Project	IEEE 802.16 Broadband Wireless Access Working Group < http://ieee802.org/16 >	
Title	Clarify downlink burst profile change management	
Date Submitted	2005-01-19	
Source(s)	Chi-Chen Lee Tzu-Ming Lin Yu-Ren Yang Industrial Technology Research Institute, Computer and Communications Research Labs, Taiwan Bldg. 11, 195 Sec. 4, Chung Hsing Rd. Chutung, HsinChu, Taiwan 310, R.O.C.	Voice: 886-3-5914579 Fax: 886-3-5829733 mailto: jjlee@itri.org.tw mailto: TMLin@itri.org.tw mailto: yryang@itri.org.tw
Re:	IEEE P802.16-REVd/D5	
Abstract	This contribution introduces clarifications for DL burst profile change management procedures.	
Purpose	Adopt into P802.16d/D5 corrigenda	
Notice	This document has been prepared to assist IEEE 802.16. It is offered as a basis for discussion and is not binding on the contributing individual(s) or organization(s). The material in this document is subject to change in form and content after further study. The contributor(s) reserve(s) the right to add, amend or withdraw material contained herein.

Clarify downlink burst profile change management

6.3.10.1 Downlink burst profile management

Figure 79—Transition to a more robust burst profile

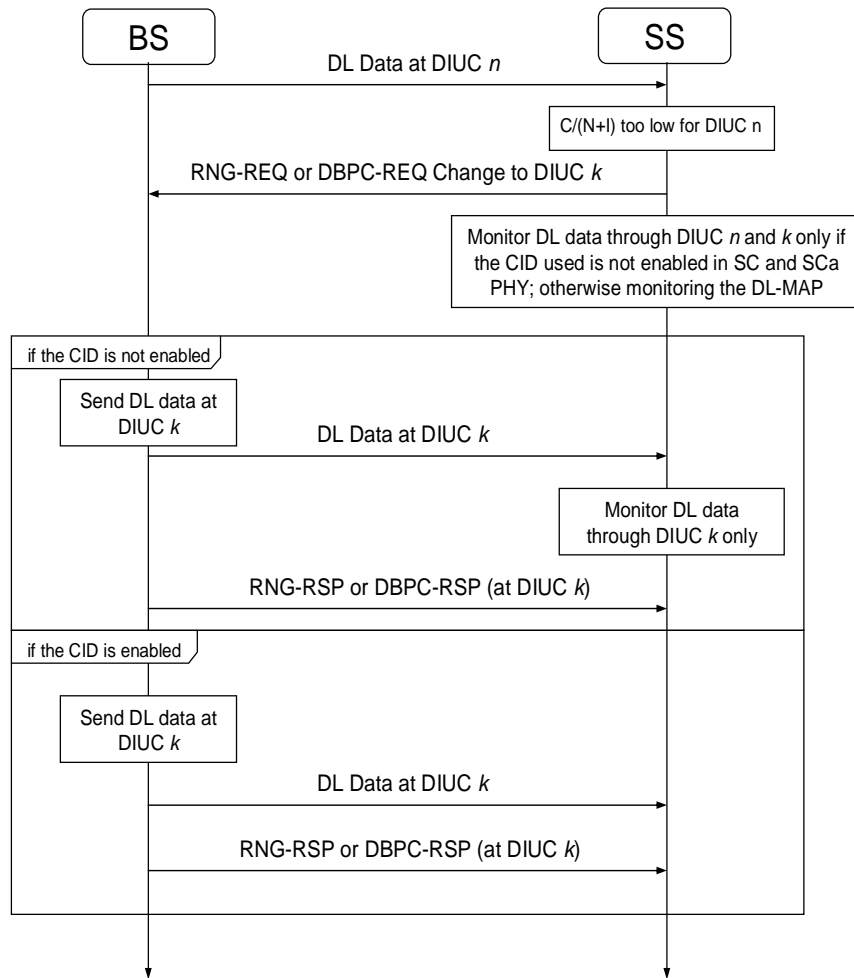
In IEEE P802.16-REVd/D5 “Figure 79 —Transition to a more robust burst profile” and “Figure 80—Transition to a less robust burst profile”, the SS must monitor DL data through two different DIUC while changing the DL burst profile. This scenario is reasonable only if the *CID used* is **not** enabled by burst profile for SC and SCa PHY (see Table 139 and Table 190). In the case of OFDM, OFDMA PHY and in the case of SC, SCa PHY that the *CID used* is enabled by burst profile, the SS’s basic CID is included in each DL-MAP_IE. Thus, the SS can check the DL-MAP for its basic CID and know what DIUC it should use. This design improves the energy efficiency of the SSs that have power consumption constraints. Due to the lack of consistency between this design and the procedures defined in specification, we provide two modified figures to clarify this issue.

[Replace Figure 79 and Figure 80 with the following figures.]

Figure 81a—Wait for response during change of DL burst profile—SS

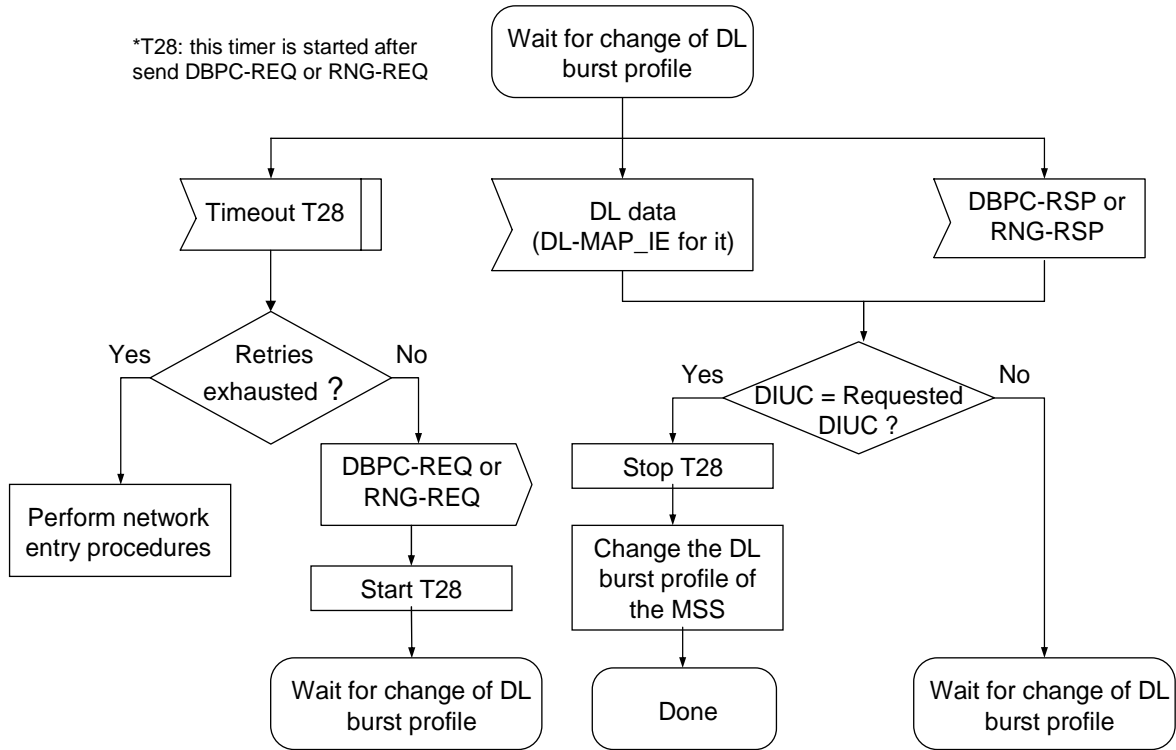
We notice that DL burst profile management does not mention how the SS deals with the lost of the change request. However, the change request may be lost due to the contention or harsh mobile environment. Therefore, the additional flow chart (see Figure 81a) is proposed to make the change of DL burst profile more robust. The new timer T28 is designed for handling the lost of the DBPC-REQ or RNG-REQ during the change of DL burst profile. Note that the BS should send DL data at new DIUC or send the DBPC-RSP or RNG-RSP to the MSS before T28 times out.

[Insert new figure before “Figure 81 – Burst profile threshold usage” with the following figure.]
